An Ordinance entitled, "AN ORDINANCE to amend the Official Zoning Map of the City of Des Moines, Iowa, set forth in Section 134-277 of the Municipal Code of the City of Des Moines, Iowa, 2000, by rezoning and changing the district classification of certain property located in the vicinity of 2301 Ingersoll Avenue from the "NPC" Neighborhood Pedestrian Commercial District to "PUD" Planned Unit Development classification",

Communication from the City Plan and Zoning Commission advising that at their meeting held August 18, 2016, the following action was taken regarding a request from Roers Investments, LLC (purchaser) represented by Brian Roers (officer) to rezone property at 2301 Ingersoll Avenue. The subject property is owned by All People Re Investment, LLC.

STAFF REPORT TO THE PLANNING COMMISSION

2301 Ingersoll Avenue

Site Concept #12

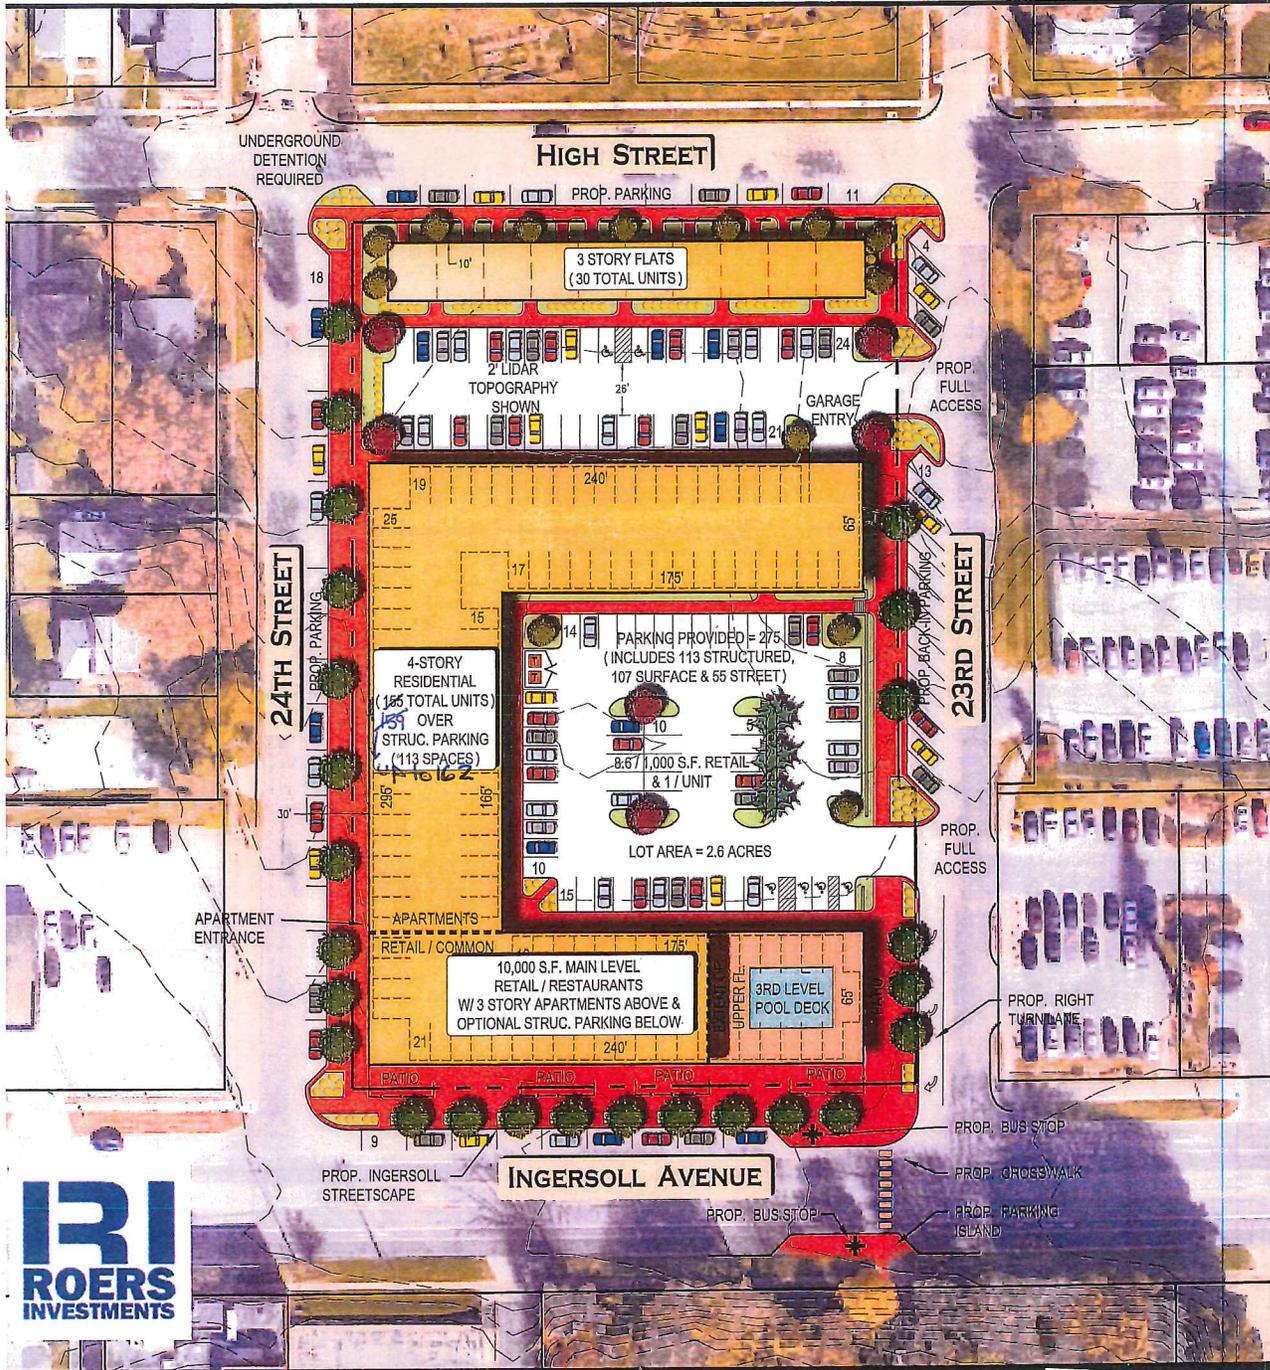
The PUD Conceptual Plan incorrectly references the Des Moines 2020 Community Character Plan and future land use designation. The Plan should be revised to state that the PlanDSM Comprehensive Plan Future Land Use Map designates the property as Community Mixed-Use Corridor and Neighborhood Node.

- 5. Landscaping & Buffering:** The submitted Conceptual Plan identifies formal streetscape plantings along all property frontages as well as plantings at the perimeter and interior of on-site surface parking lots. Ingersoll Avenue Streetscape elements include but are not limited to class "A" sidewalk generally scored into 2-foot by 2-foot squares with an integrated street curb, planter beds with a raised curb and railing, street trees, shrub/flower plantings, a black LED Autobahn street light fixture with a black pole and the undergrounding of overhead utility lines. Additional plantings are needed along the building foundations to soften the buildings' presence along the sidewalks. Staff recommends that ornamental fencing be provided along the perimeters of the surface parking lots that adjoin public sidewalks to provide additional urban edge. A tree protection and mitigation plan is required for administrative review by City staff pursuant to Chapter 42, Article X of the City Code should the property be rezoned as noted on the PUD Conceptual Plan. The Concept Plan indicates that utility meters placed on new building facades shall not face parking lots or public streets. Staff believes that this note should be revised to state that any building mounted utility meters shall not face public streets. All building mounted utility meters shall be located within the building or face off-street parking areas and be screened from view of public streets to the satisfaction of the Planning Administrator. The Conceptual Plan indicates that any transformers, junction boxes, air conditioner units, or other mechanical equipment over 3 feet in height cannot be located within a required setback. Staff recommends that this

note be revised state that any transformers shall be located within the buildings or within off-street parking areas and screened from view of public streets to the satisfaction of the Planning Administrator. All mechanical and HVAC equipment shall be screened and/or architecturally compatible with the building and be designed to the satisfaction of the Planning Administrator.

6. **Signage:** The PUD Conceptual Plan indicates that signage shall be monument or directory, but in no case pole mounted. Staff recommends that all signage be building mounted and limited to the Ingersoll, 23rd and 24th Street frontages for the restaurant/retail portion of the urban, mixed-use building. In addition, building mounted signage could be placed on the north façade of the restaurant/retail portion of the urban and mixed use building facing the off-street parking lot that is at the center of the mixed use building. All other signage limitations (size and number of signs) shall be based on allowances of the NPC district regulations.

7. **Refuse Collection:** The proposed PUD Conceptual Plan does not indicate the locations of refuse collection containers. The Plan includes a note that trash containers will be screened by enclosures constructed with masonry walls and steel gates to match the primary structures. Staff recommends that the PUD Conceptual Plan demonstrate the location of any outdoor refuse collection container enclosure and provide a statement that any such structure will be constructed with brick or stone materials that match the masonry materials used on the primary structure and 100% opaque steel gates. Any enclosure structure should also include non-gated pedestrian entrance and be sized to accommodate recycling containers. If no outdoor enclosures are proposed, then a note should be added to state that all refuse collection containers must be located within a building.

8. **Site Lighting:** The proposed PUD Conceptual Plan includes a note that lighting must be low glare, cut-off type fixtures to reduce glare. Staff recommends that a note be added to state that any pole mounted lighting along private walkways shall not exceed 15 feet in height and any pole mounted lighting in a parking area shall not exceed 20 feet in height. Private light poles and pole mounted light fixtures are to be similar in style to a KIM Archetype light fixture, an AEL Autobahn LED Series ATBO light fixture, or of other similar esthetic quality as approved by the Planning Administrator.

1. The Concept Plan notes shall be revised to state that the PlanDSM Comprehensive Plan Future Land Use Map designates the property as Community Mixed-Use Corridor and Neighborhood Node.

2. Streetscape shall be provided along all street frontages subject to review and approval of the Planning Administrator. Ingersoll Avenue elements include but are not limited to class "A" sidewalk generally scored into 2-foot by 2-foot squares with an integrated street curb, planter beds with a raised curb and railing, street trees, shrub/flower plantings, a black LED Autobahn street light fixture with a black pole and the undergrounding of overhead utility lines.

3. All overhead utility and electrical service lines adjoining and within the site shall be undergrounded.
4. All building architecture and site landscaping shall be subject to review and approval by Planning Administrator and shall include provision of detailed elements such as full-dimensional brick, metal balconies, window and corner trim, concrete detailing on any exposed concrete foundation walls of the underground parking area, etc.

5. All grading is subject to an approved grading permit and soil erosion control plan. The applicant is required to demonstrate compliance with the City's storm water Management requirements to the satisfaction of the City's Permit and Development Center.

6. A grease interceptor will be provided for all restaurant uses.
7. A traffic signal at 23rd Street is not warranted at this time but the developer will provide conduit for a potential future signal installation at this location.

9. The applicant shall provide calculations and a section of 23rd Street to the City Traffic and Transportation Division with dimensions to show if the proposed back-in angle parking will comply with City code. If extra width is needed, it will have to come from the west side of the street. Otherwise, parallel parking will be provided.

12. Additional plantings shall be provided along the building foundations to soften the buildings' presence along the sidewalks.
13. Ornamental fencing shall be provided along the perimeters of the surface parking lots that adjoin public sidewalks to provide additional urban edge.

14. A tree protection and mitigation plan shall be submitted for administrative review by City staff pursuant to Chapter 42, Article X of the City Code.

15. Any building mounted utility meters shall not face public streets. All building mounted utility meters shall be located within the building or face off-street parking areas and be screened from view of public streets to the satisfaction of the Planning Administrator.

16. Any transformers shall be located within the buildings or within off-street parking areas and screened from view of public streets to the satisfaction of the Planning Administrator.

17. All mechanical and HVAC equipment shall be screened and/or architecturally compatible with the building and be designed to the satisfaction of the Planning Administrator.

19. The PUD Conceptual Plan demonstrate the location of any outdoor refuse collection container enclosure and provide a statement that any such structure will be constructed with brick or stone materials that match the masonry materials used on the primary structure and 100% opaque steel gates. Any enclosure structure should also include non-gated pedestrian entrance and be sized to accommodate recycling containers. If no outdoor enclosures are proposed, then a note should be added to state that all refuse collection containers must be located within a building.

21. Any pole mounted lighting along private walkways shall not exceed 15 feet in height and any pole mounted lighting in a parking area shall not exceed 20 feet in height. Private light poles and pole mounted light fixtures are to be similar in style to a KIM Archetype light fixture, an AEL Autobahn LED Series ATBO light fixture, or of other similar esthetic quality as approved by the Planning Administrator.
